DANIEL L. CLAASSEN 1ST ADDITION **AN ADDITION TO WICHITA, SEDGWICK COUNTY, KANSAS**

RE: S/D 98-100 -- One-Step Final Plat of DANIEL L. CLAASSEN ADDITION

RE: S/D 98-100 -- One-Step Final Plat of DANIEL L. CLAASSEN ADDITON

CASE NUMBER: S/D 98-100 - DANIEL L. CLAASSEN ADDITION

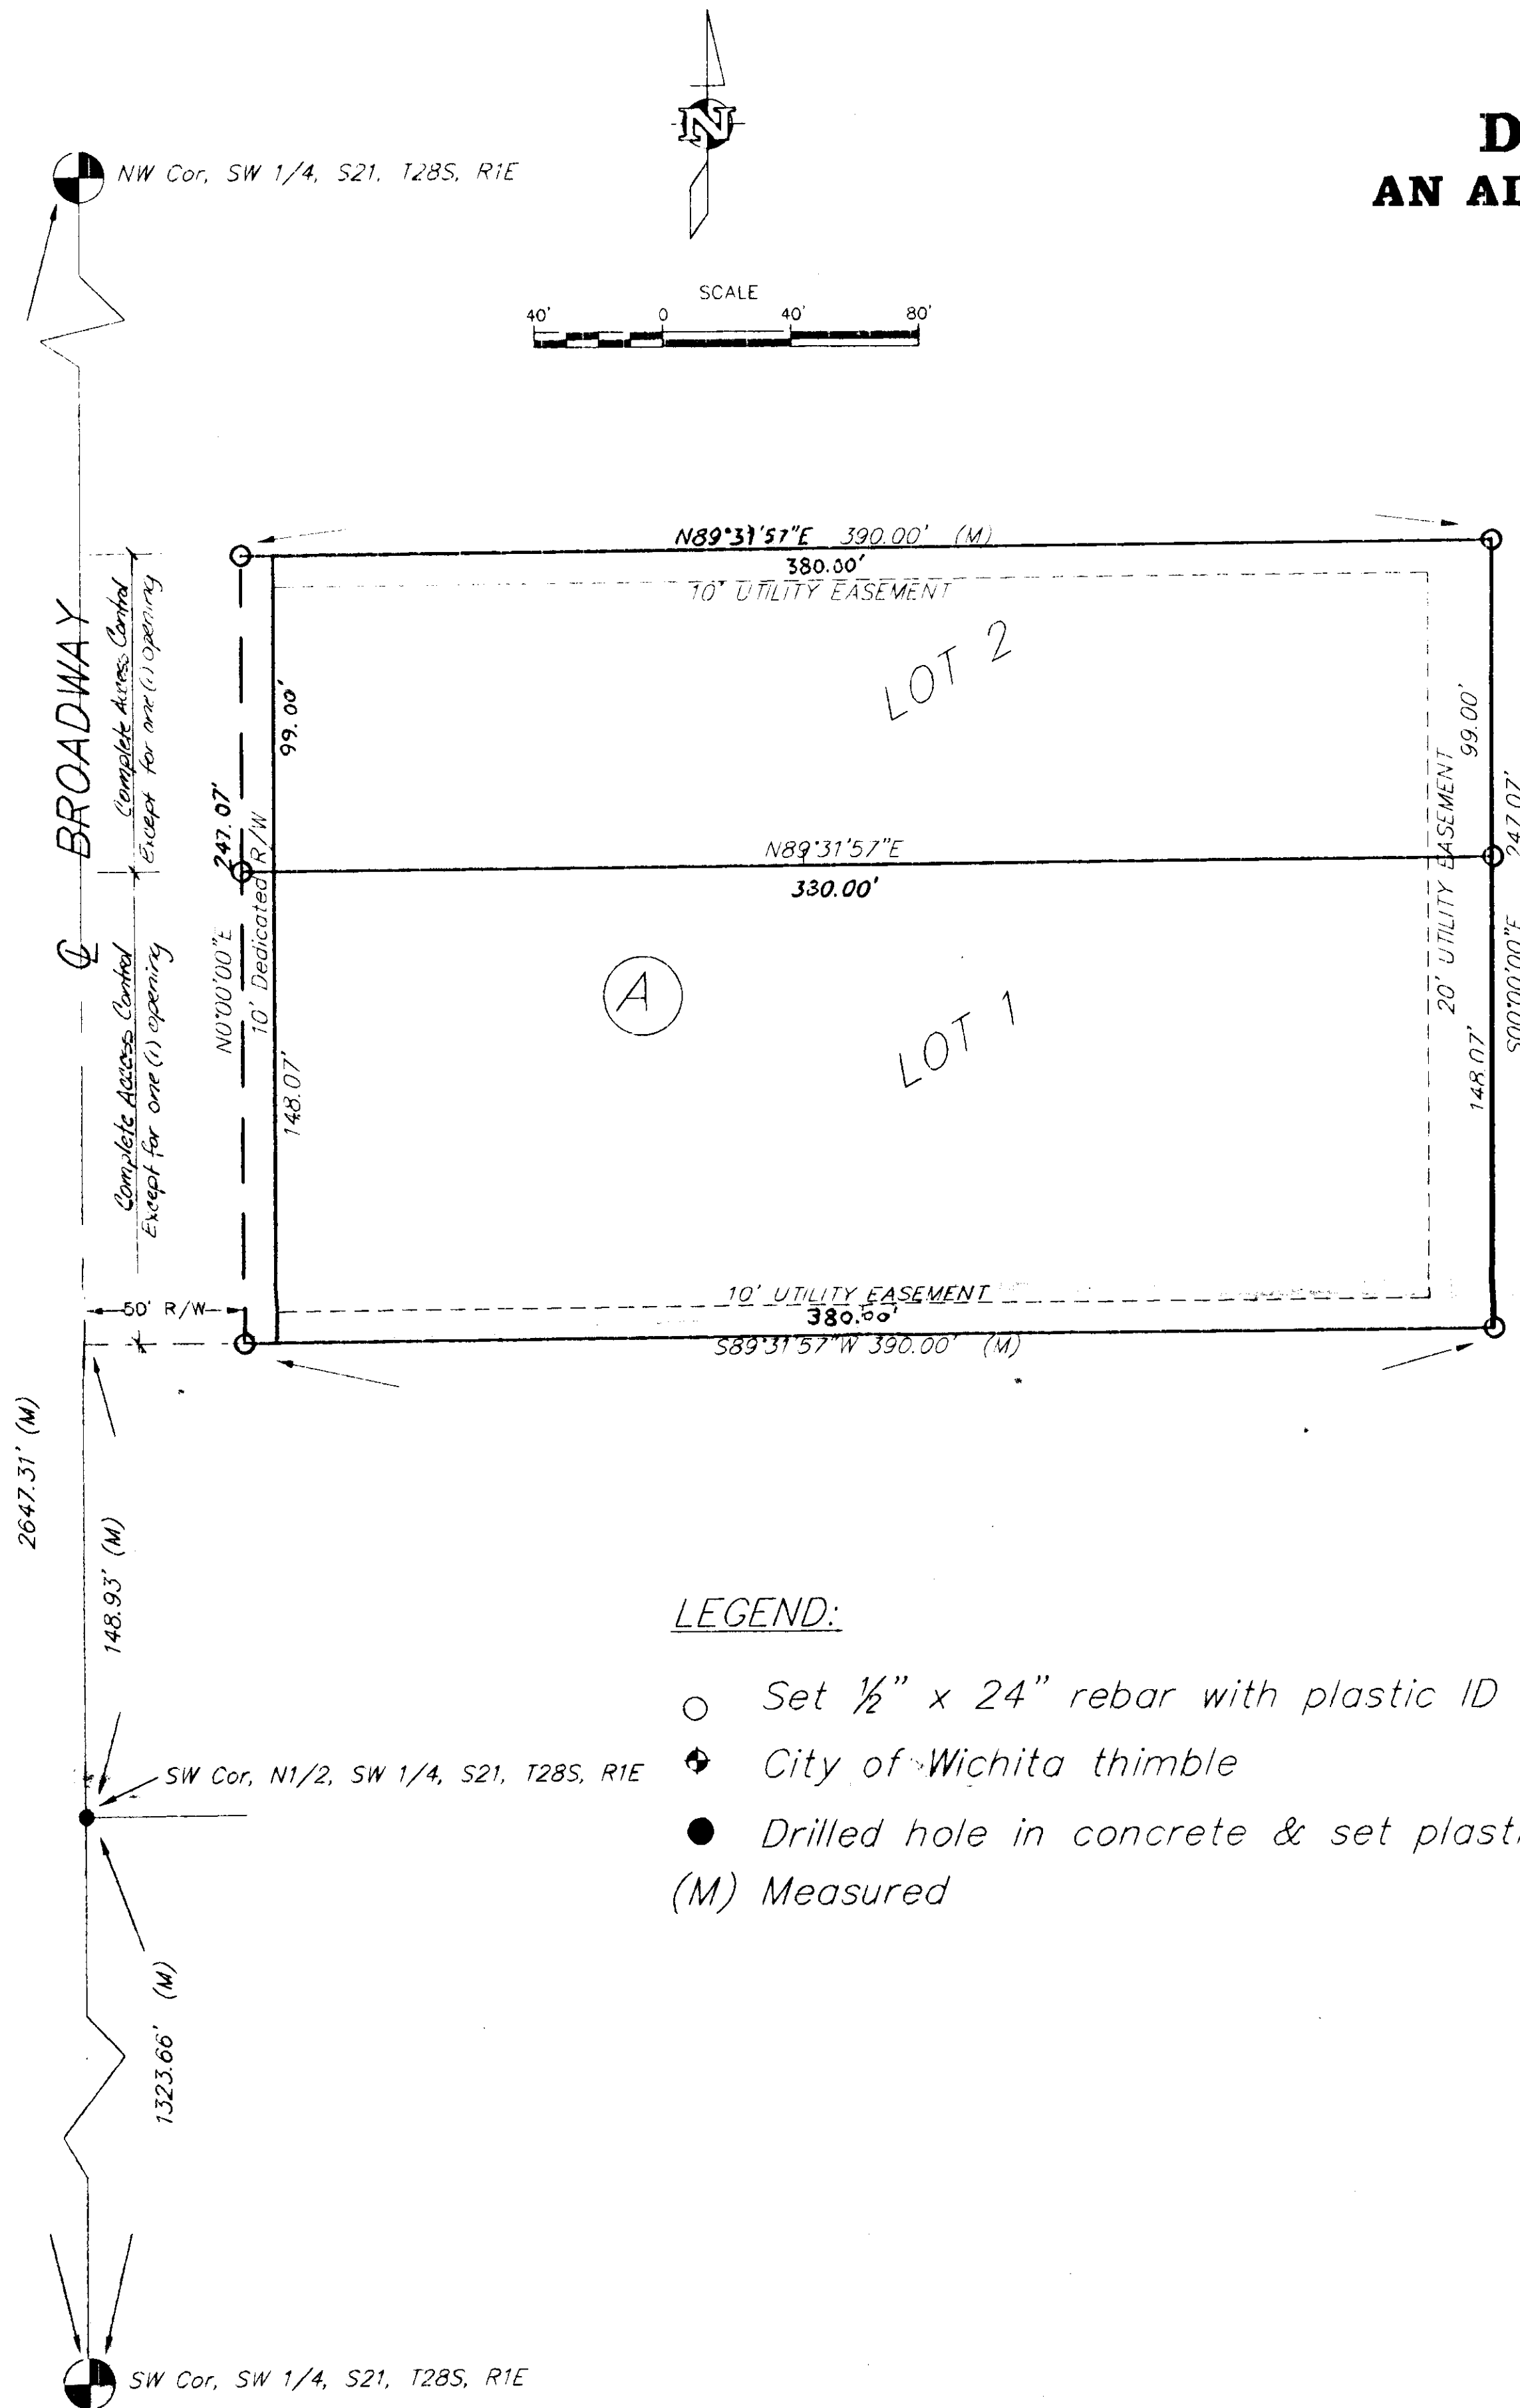
- B. **City Engineering** needs to verify if any guarantees for municipal services or any easements are required. *A guarantee needs to be submitted for a sanitary sewer extension to Lot 1. The Applicant shall contact the adjoining landowner to the south regarding participation in the sewer petition. The utility easement along the rear lot lines needs to be increased to 20 feet to accommodate sanitary sewer. Additional right-of-way needs to be dedicated to line up with the adjoining north and south plats.*

- F. Traffic Engineering needs to comment on the number of allowable access openings along Broadway. The dedication of access controls shall be included on the final plat tracing and referenced in the plat's text. The Applicant shall guarantee the closure of any driveway openings being located in areas of complete access control or that exceed the number of allowed openings. *The final tracing shall denote one opening per lot.*

- G. The spelling of "Claassen" needs to be corrected on the final plat tracing.
- H. The MAPC Chairman needs to be revised to "William M. Johnson".
- I. Traffic Engineering needs to comment on the need for improvements to Broadway.

- J. The Applicant is reminded that a platting binder is required with the final plat tracing.
- K. The lot depth to width ratio exceeds 3 to 1 for Lot 2, and a modification from the Subdivision regulations will be needed for approval of this plat.

- S. The representatives from the utility companies should be prepared to comment on the need for any additional utility easements to be platted on this property. *The Applicant intends to relocate the utility easement between the two lots to the north and south lines of the plat.*
